**FRIENDS
OF THE
RIVER**

April 29, 2005

Re: Comments on Battle Creek Restoration Project SEIS/REIR

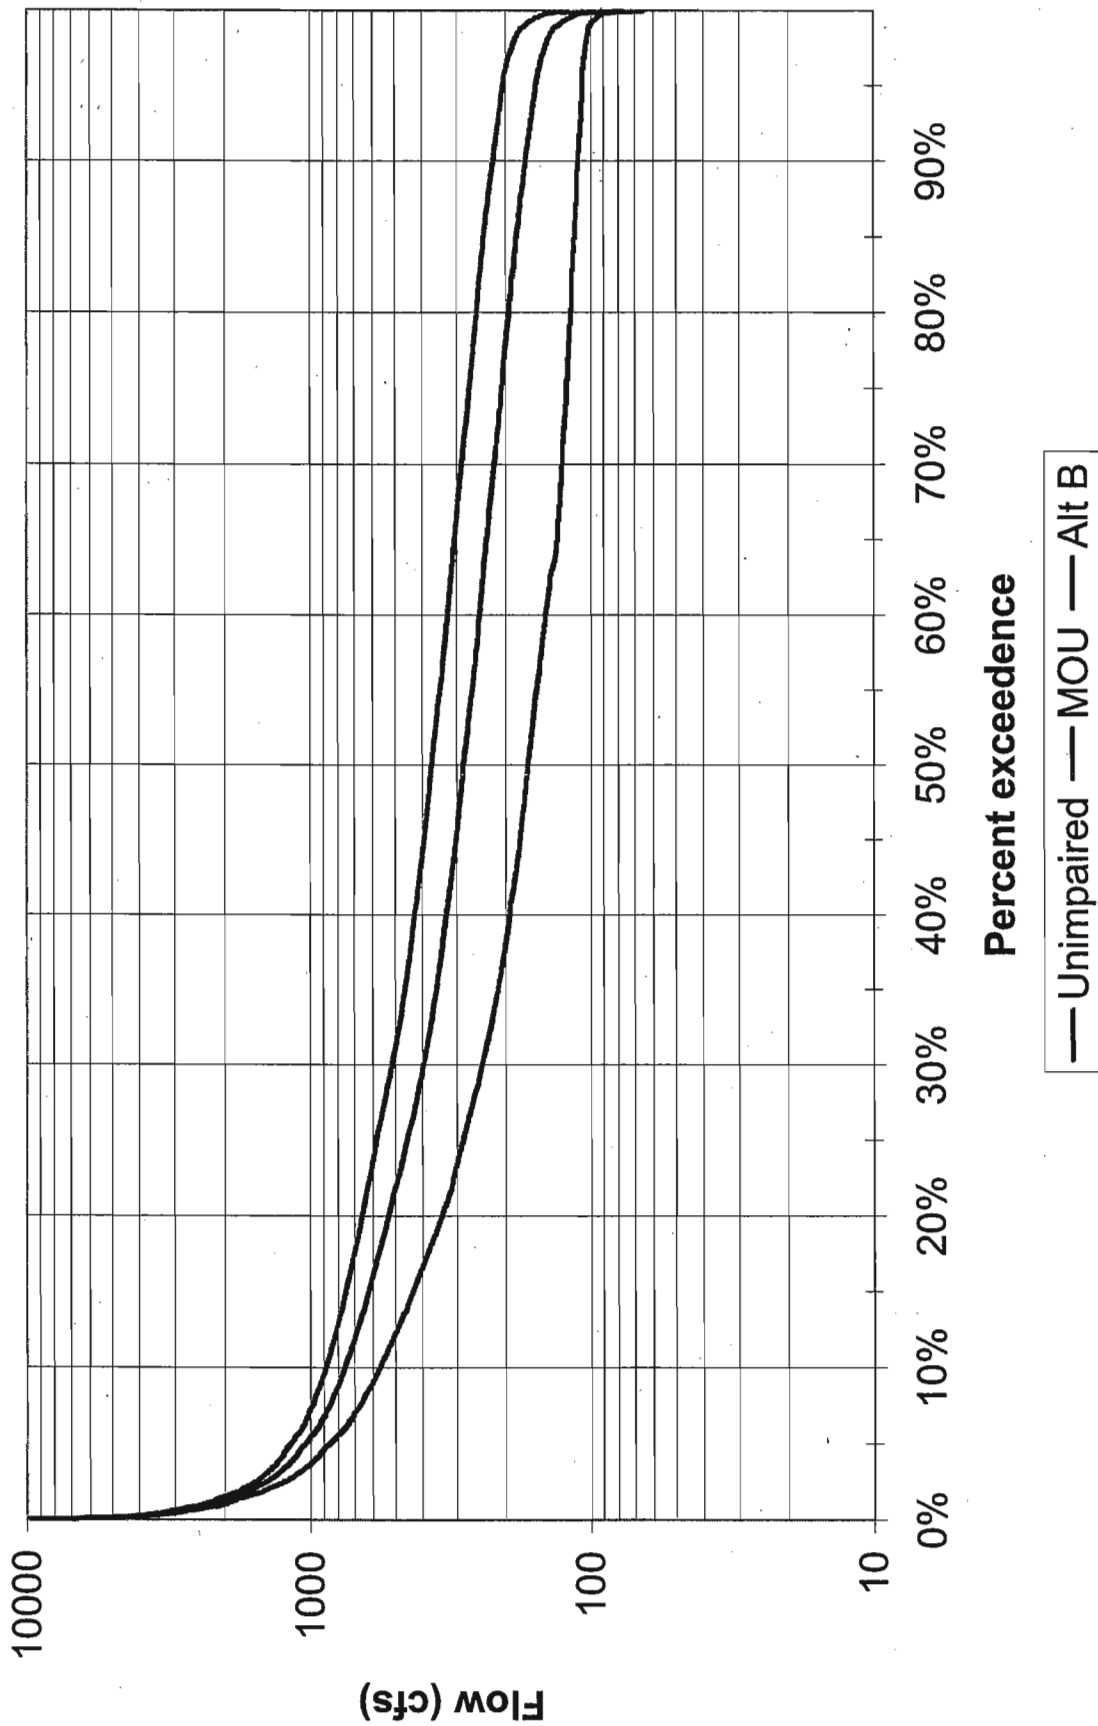
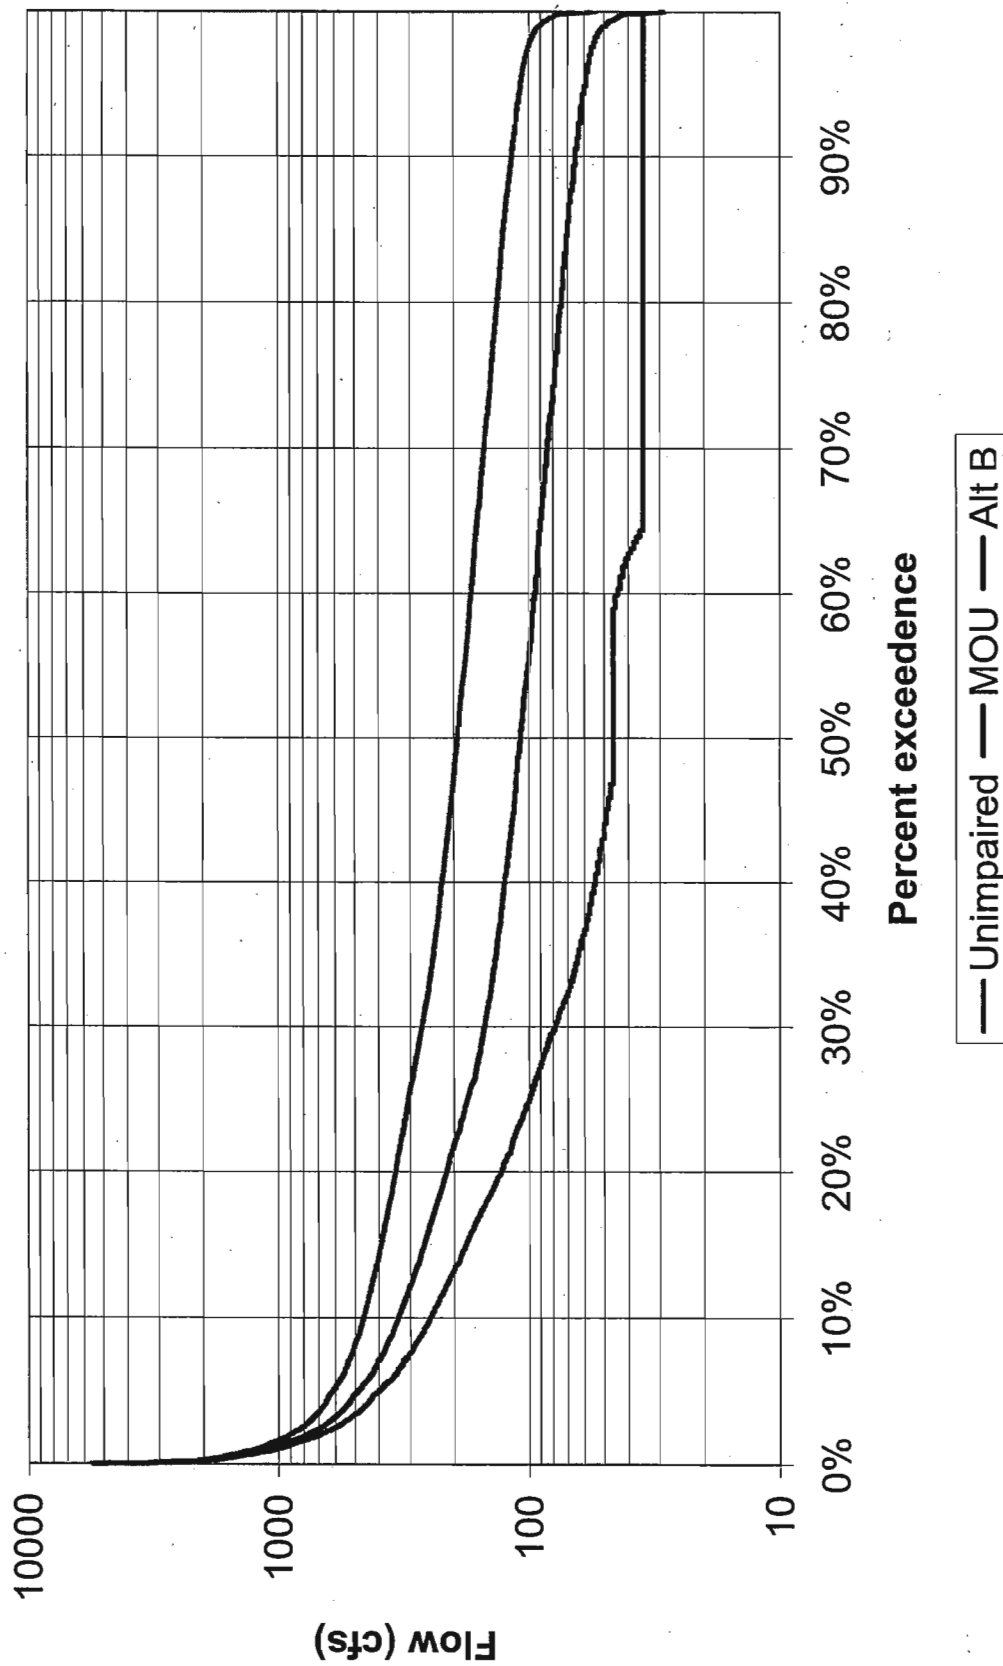
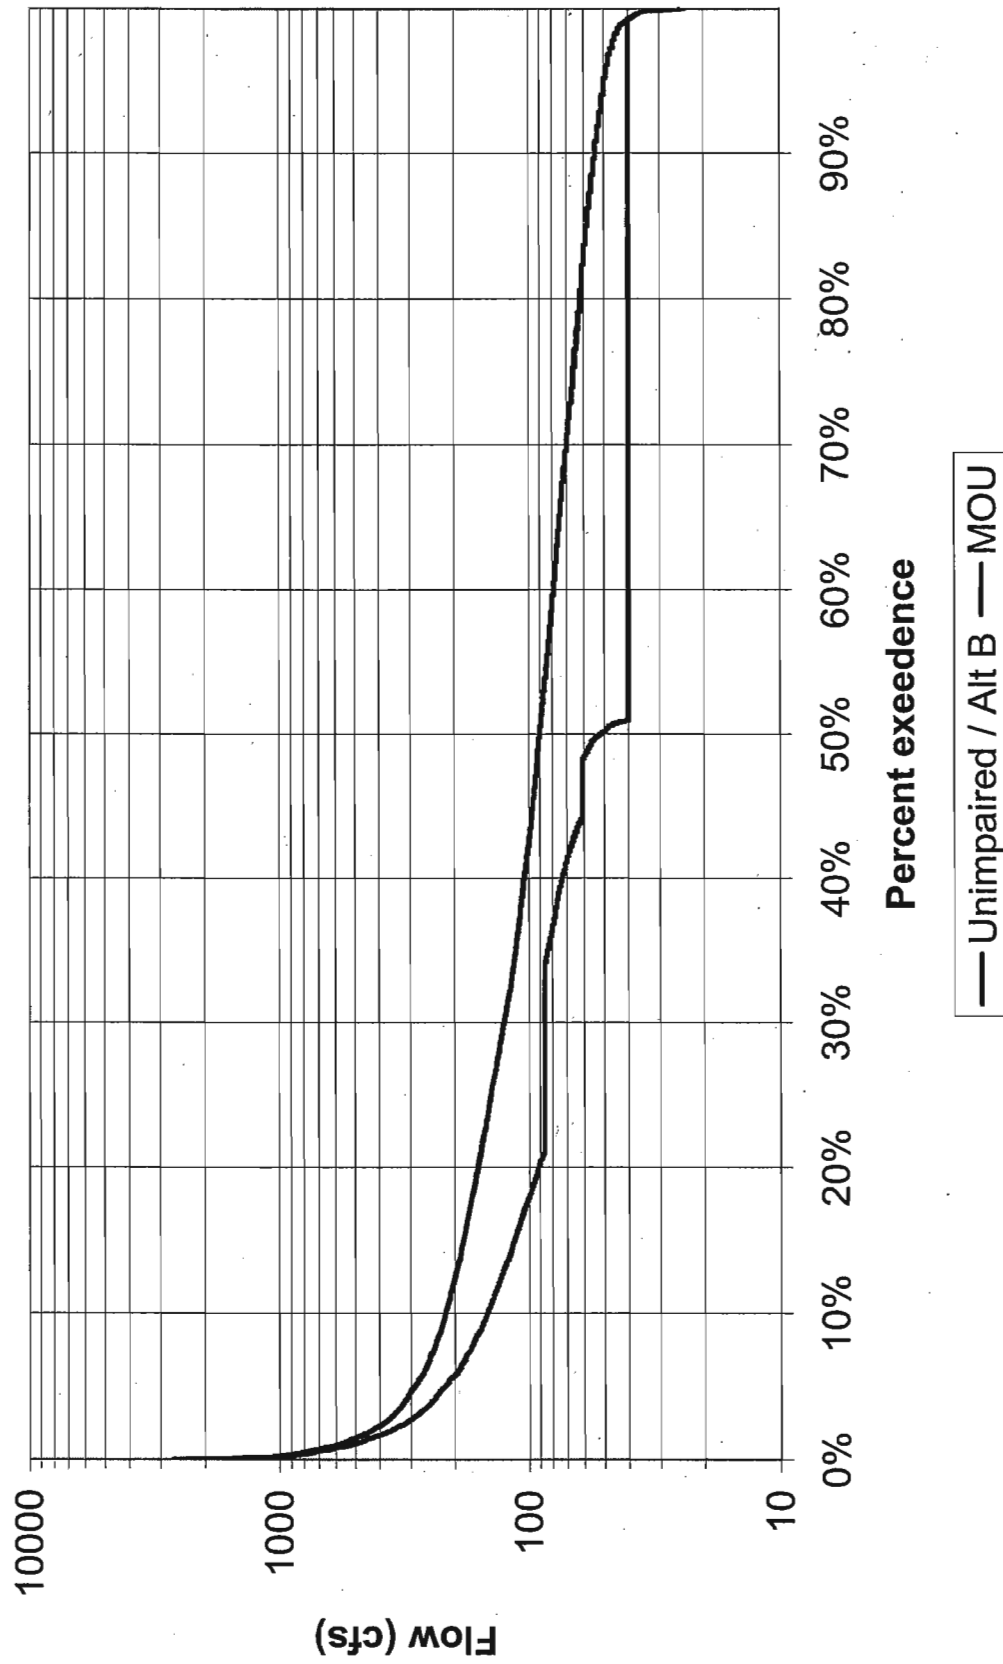
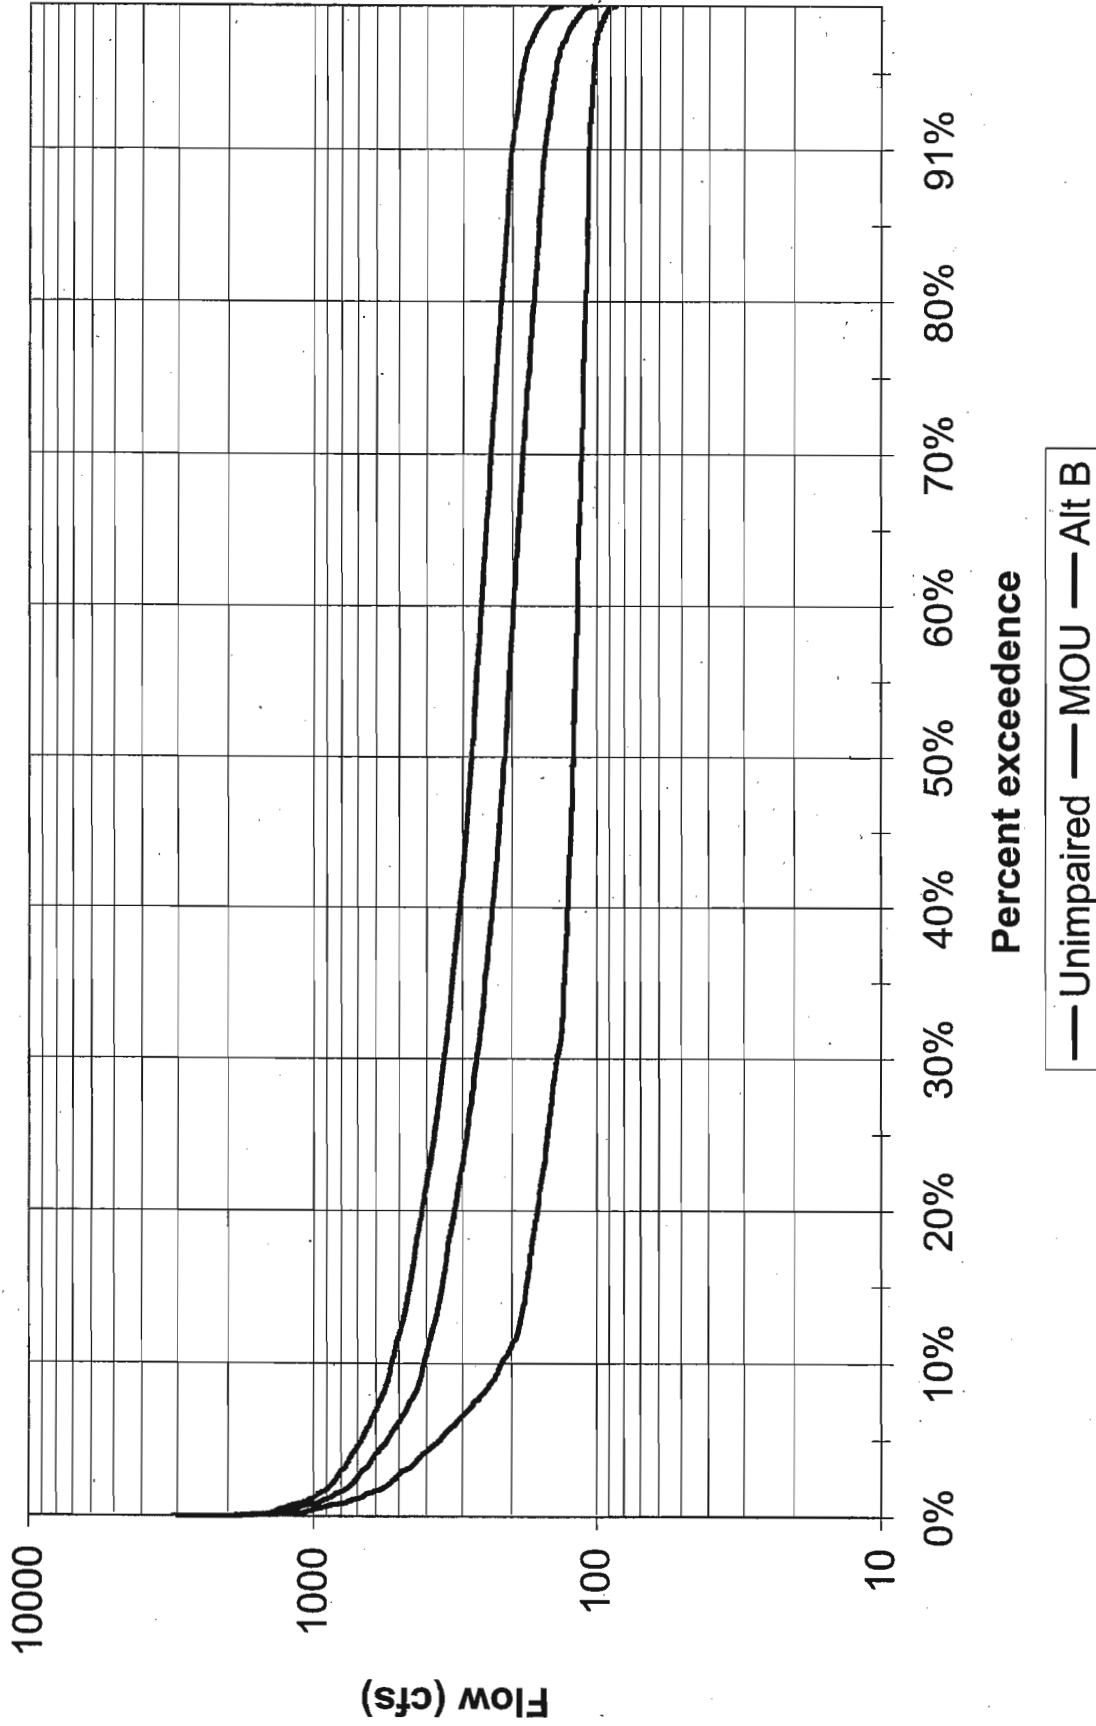
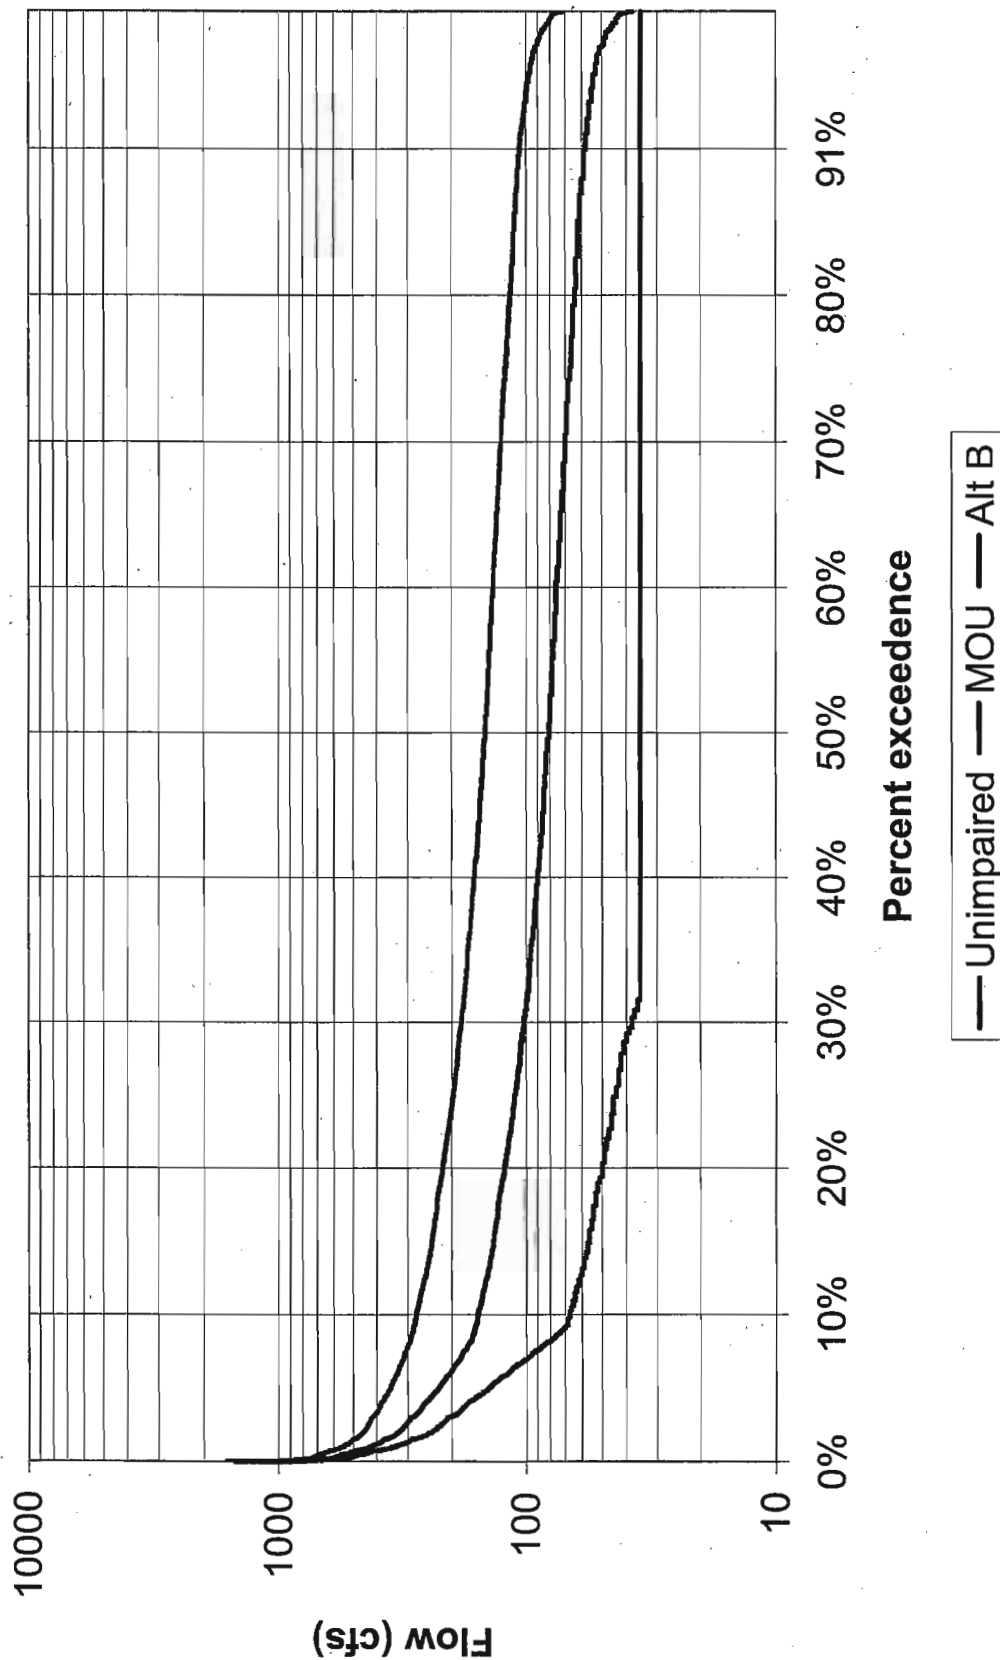
- **Duration.** Clear differences in the duration of flows are illustrated in Figures E-1 to E-6, comparative flow exceedence curves for the mainstem, Eagle Canyon, and Inskip reaches. For example, if flows below 50 cfs were found to form a natural barrier in Eagle Canyon, Figure E-5 shows MOU flows would exceed that amount in summer 20% of the time (24 days), based on the 1962-2002 period of record. Alt B flows would exceed 50 cfs 97% of the time (118 days).
